London Luton Airport Expansion

8.74 Applicant's response to Written Questions - Noise

**London Luton Airport Expansion Development Consent
Order 202x**

**8.74 APPLICANT'S RESPONSE TO WRITTEN QUESTIONS -
NOISE**

Inset 4-1: 2022 Departure Profiles

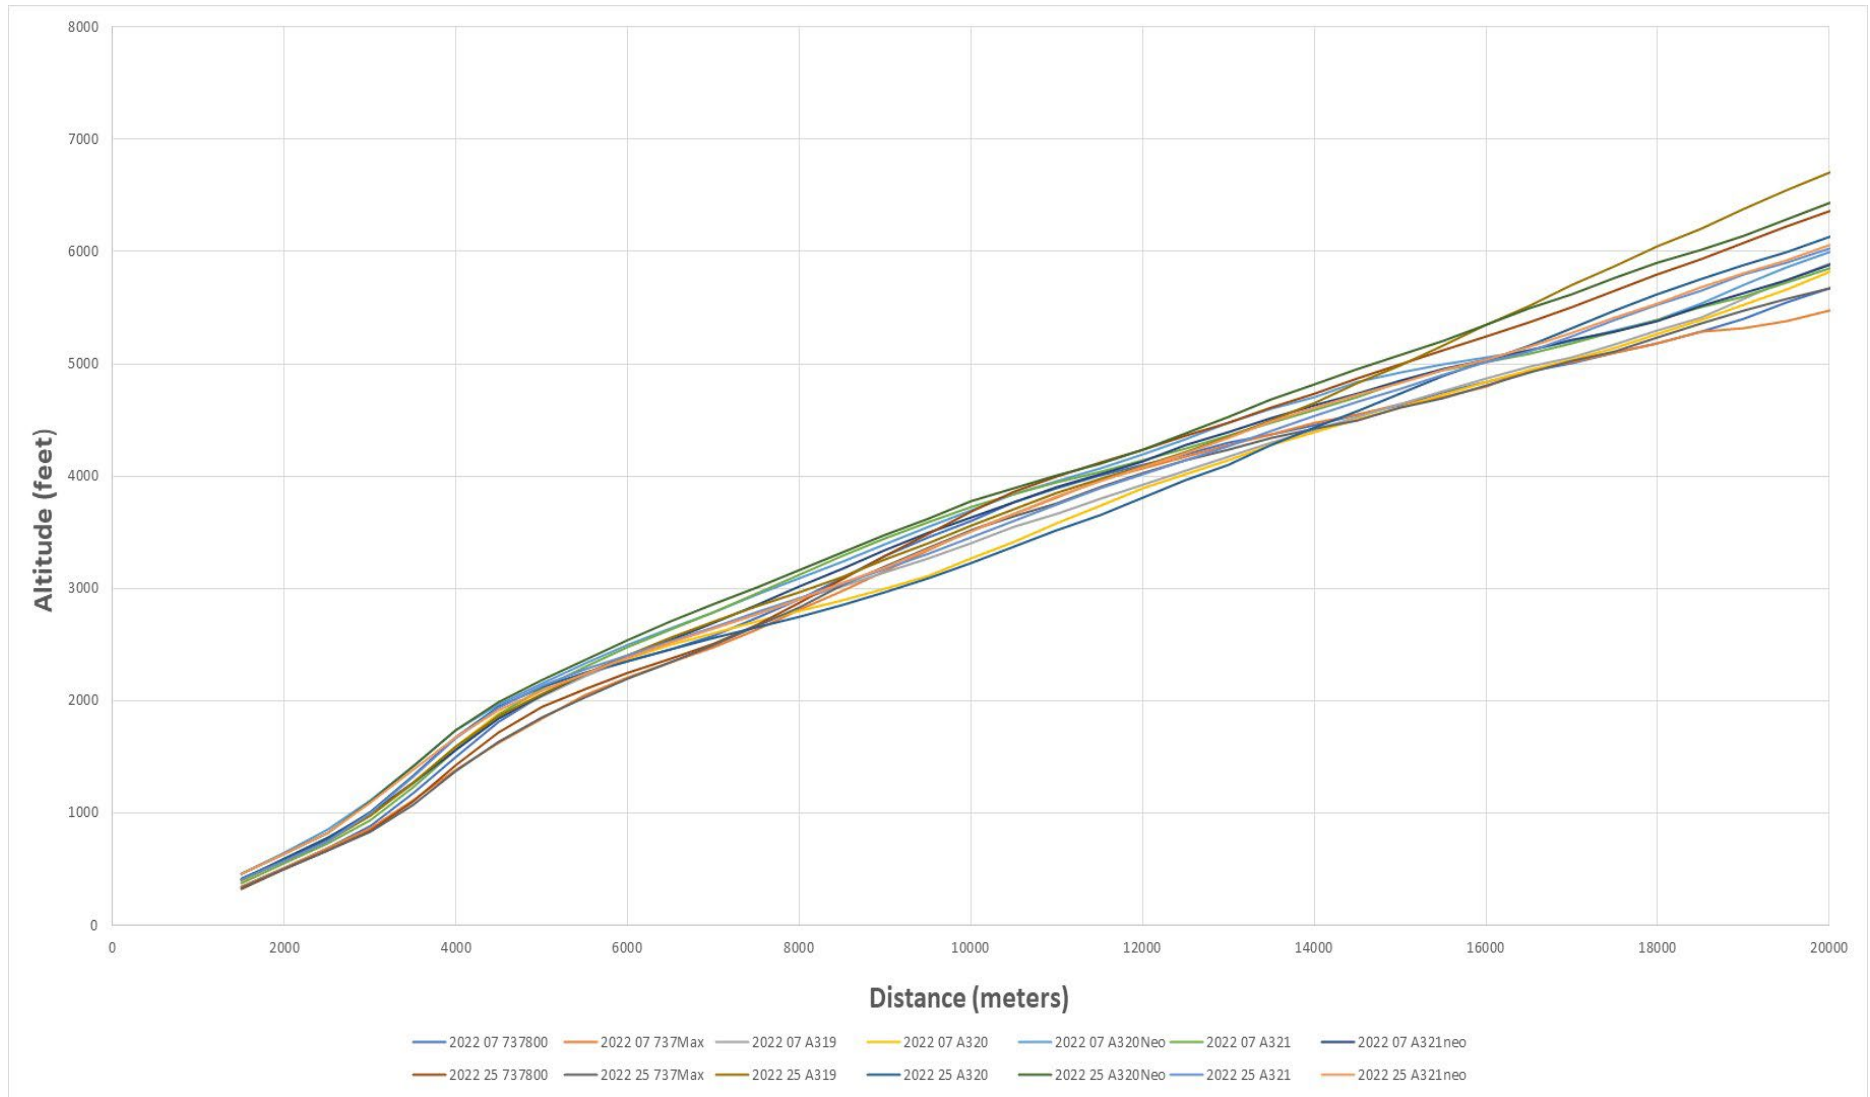
1.1.1 This document provides a response to the Examining Authority's Written Question NO.1.16 **[PD-010]**:

“Conversion between Integrated Noise Model (INM) and AEDT model

ES Appendix 16.1 [AS-096, section 6.16] explains that INM contour area limits show a relatively good fit with AEDT contour area limits, although there is some difference for 25 departure routes. This is assumed to be acceptable on the basis that 2019 radar data shows good correlation between departure profiles on both runways. Is radar data available for other years to support this assumption?”

3.1.1 To provide an indication of the correlation between departures on 07 and 25 runways, analysis of 2022 departure profiles has been undertaken as requested and this is presented in Inset 4-1. This analysis shows that, for all aircraft operating in 2022, the departure profiles are reasonably consistent regardless of whether departing on the 07 or 25 runway¹.
